Memorandum

To: MPO Policy Board
From: Sandy Shackelford, Director of Planning & Transportation
Date: June 14, 2021
Reference: Smart Scale Round 5 – CTAC Discussion Summary

CTAC Hydraulic Road/Route 29 Intersection Improvement:

CTAC Rivanna River Bicycle and Pedestrian Crossing:

Lee Kondor Consulting Engineer

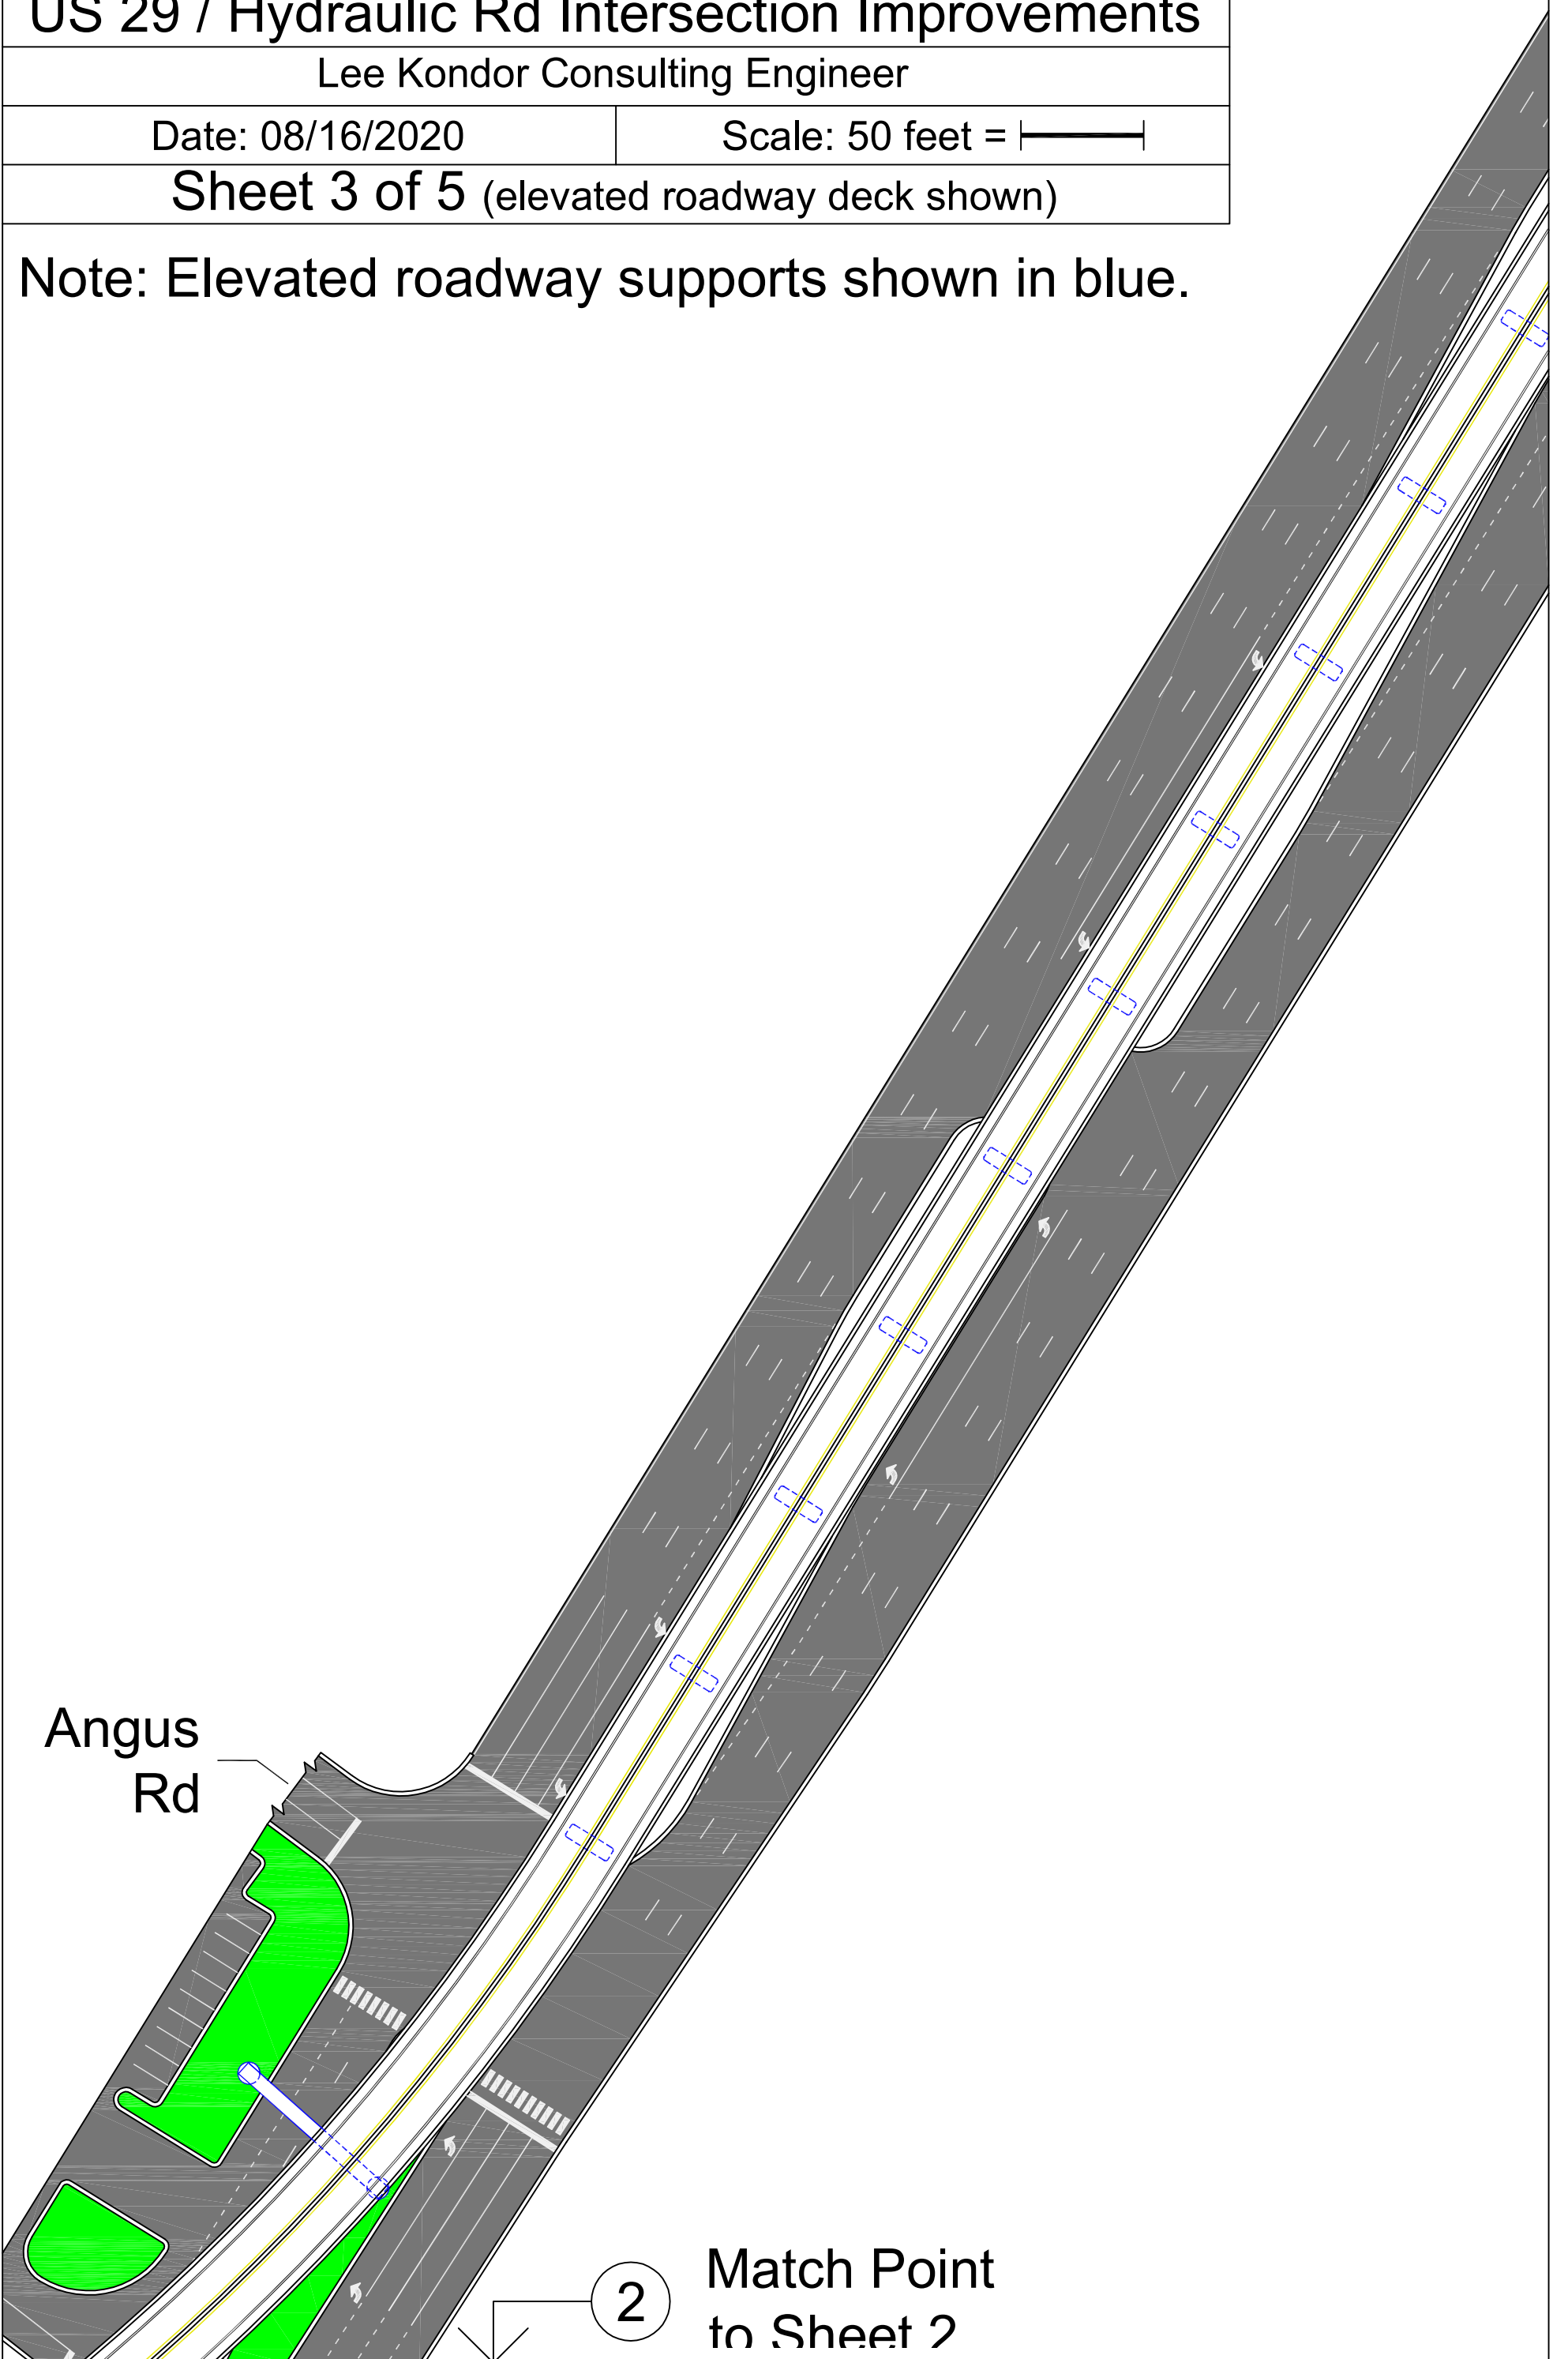
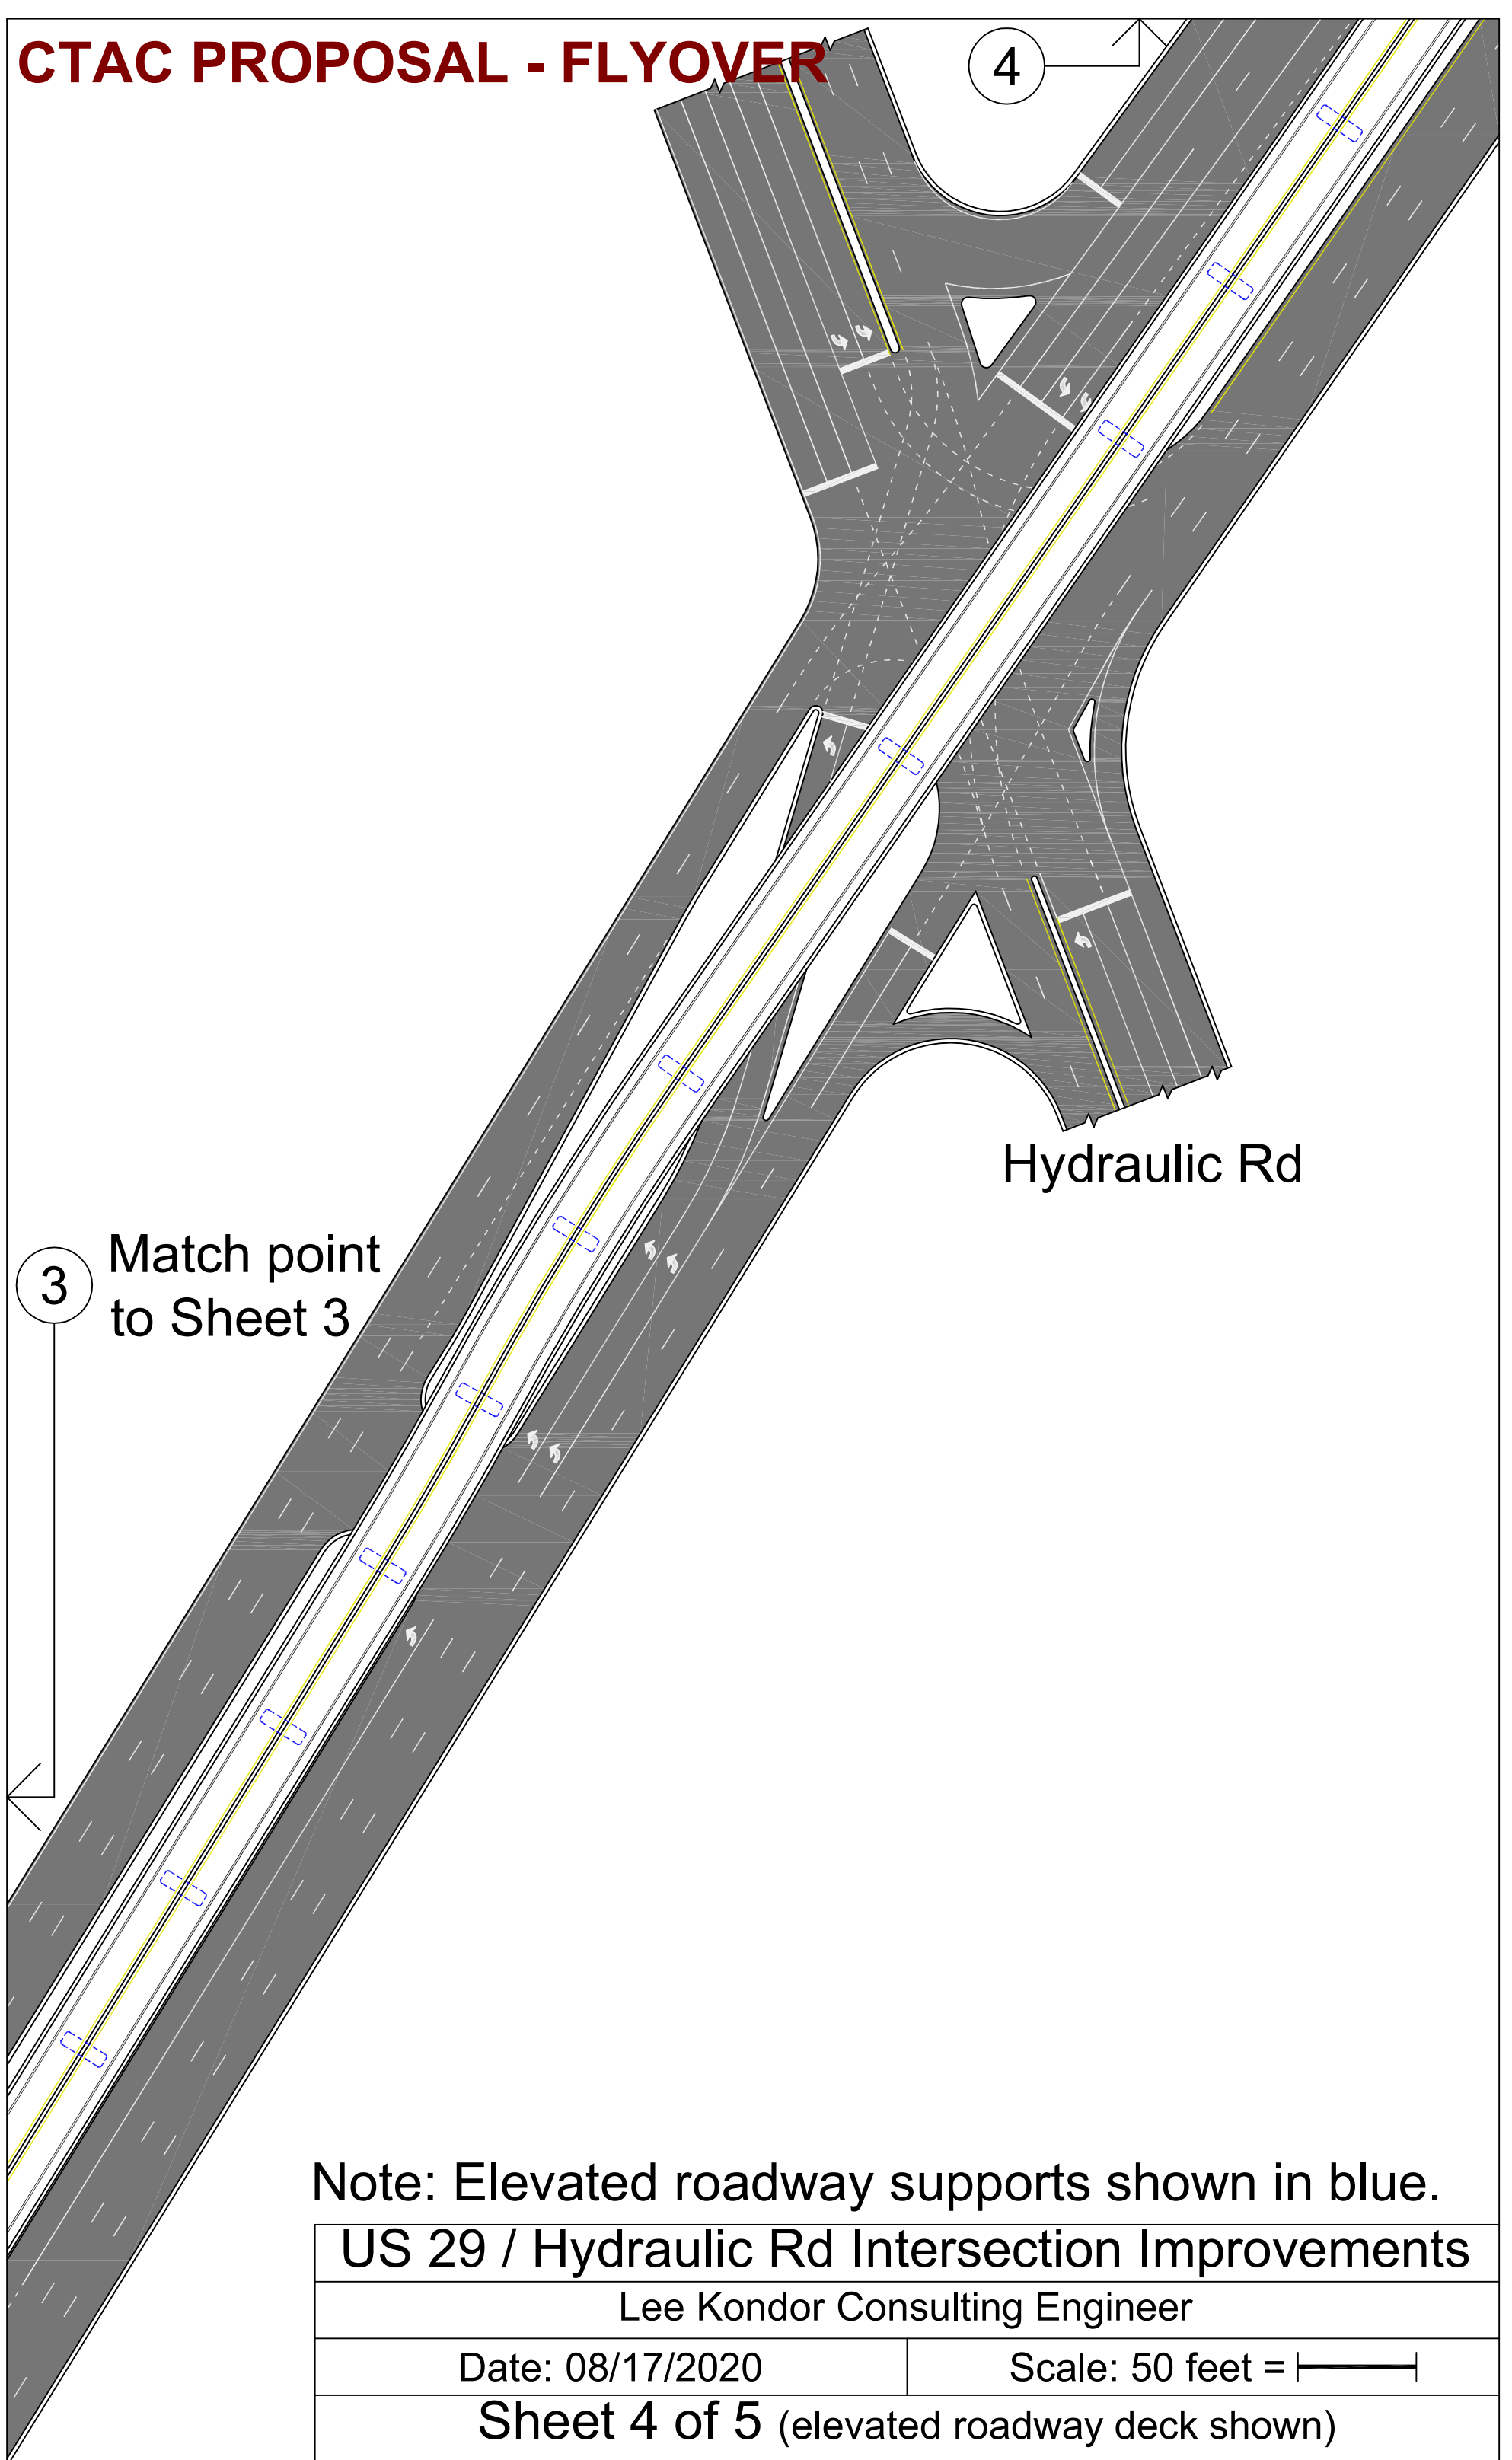
- Appreciation for the work Mr. Kondor put into developing the proposal.
- Concerns regarding the financial implications of pursuing this alternative intersection design considering the likely impacts to the Hydraulic/29 intersection improvements awarded in Round 4 and the loss of the Solutions 29 funding that was applied to that application.
- Concerns regarding the use of the 29 median to construct the proposed ramp and how that could limit future opportunities to potentially expand transit service along US 29.
- A desire to prioritize other projects that would support the development of multi-modal infrastructure.
- Concern that the proposed configuration would make pedestrian movements more challenging across US 29.
- Concerns regarding the safety of the ramp during adverse weather conditions.
- Concerns regarding the length of construction and impacts on local businesses.

- The proposed project would have congestion relief benefits by removing through traffic from the section of Emmett Street from Hydraulic Road South.
- It is unlikely that this project is eligible for funding since improvements to the Hydraulic Road/US 29 intersection were recommended for funding in SMART SCALE Round 4. To pursue this project, the MPO would have to decline the previous award and forego the \$18 million of Solutions 29 money that was allocated for congestion relief in the area prior to submitting this as an application. This application would replace the entirety of the previously awarded application, which includes the Hydraulic/29 intersection improvements, the Zan Road bike and pedestrian bridge, shared use paths along Hydraulic Road from Brandywine Drive to Michie Drive, and the roundabout at Hydraulic Road and Hillsdale Drive.

- The cost estimates have not been verified by VDOT staff, and it is possible that the estimated cost for the project would increase upon a VDOT review.

- The City of Charlottesville has extreme reservations about an elevated roadway/bridge system at this location within the City based on the initial costs as well as future maintenance, inspections, and eventual replacement expenses.
- A similar design was considered as part of the Solutions 29 Advisory Panel and was not recommended to move forward by the panel at the time that the final recommendations were developed.

No action is requested from the Policy Board at this time. CA-MPO staff will include the CTAC-proposed flyover concept to the list of potential projects for consideration by the Policy Board at their meeting on July 28, 2021. If there are any questions or comments, please contact Sandy Shackelford at sshackelford@tjpd.org.
